AIO Card ASIC Digital Noise Modification

FIGURE 4. ASIC Modifications

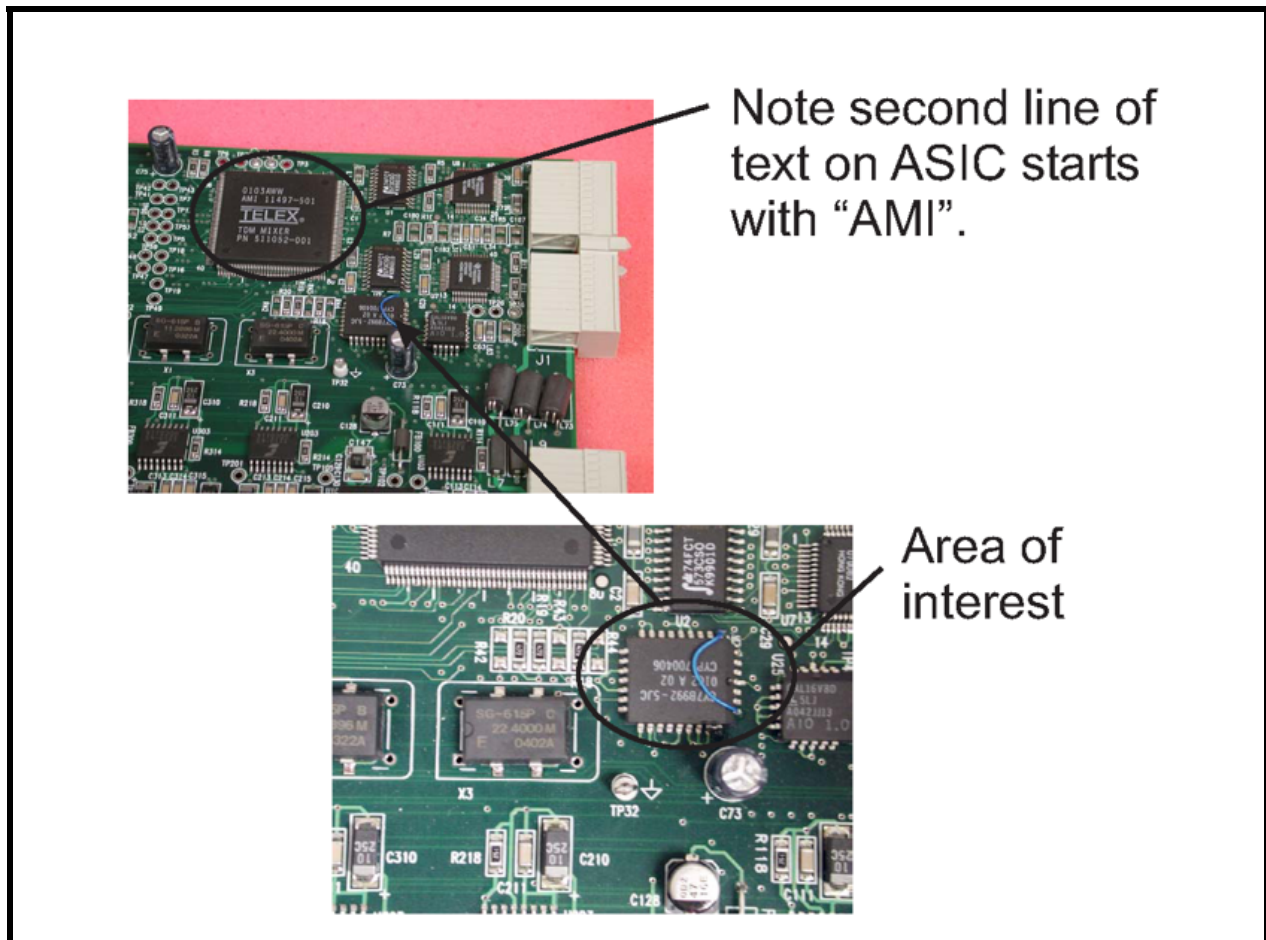
An audible sizzling or frying noise can be heard in Port-to-Port audio through the ADAM Matrix. This is more prevalent in end cards.

A timing problem exists in Telex TDM ASICs fabricated by AMI.

1. Using kynar or other suitable jumper wire, **run a jumper from U5 pin 5 to U5 pin 30**, as shown in the photo below.
2. Create a **solder bridge between pins 28 and 29 on U5**.
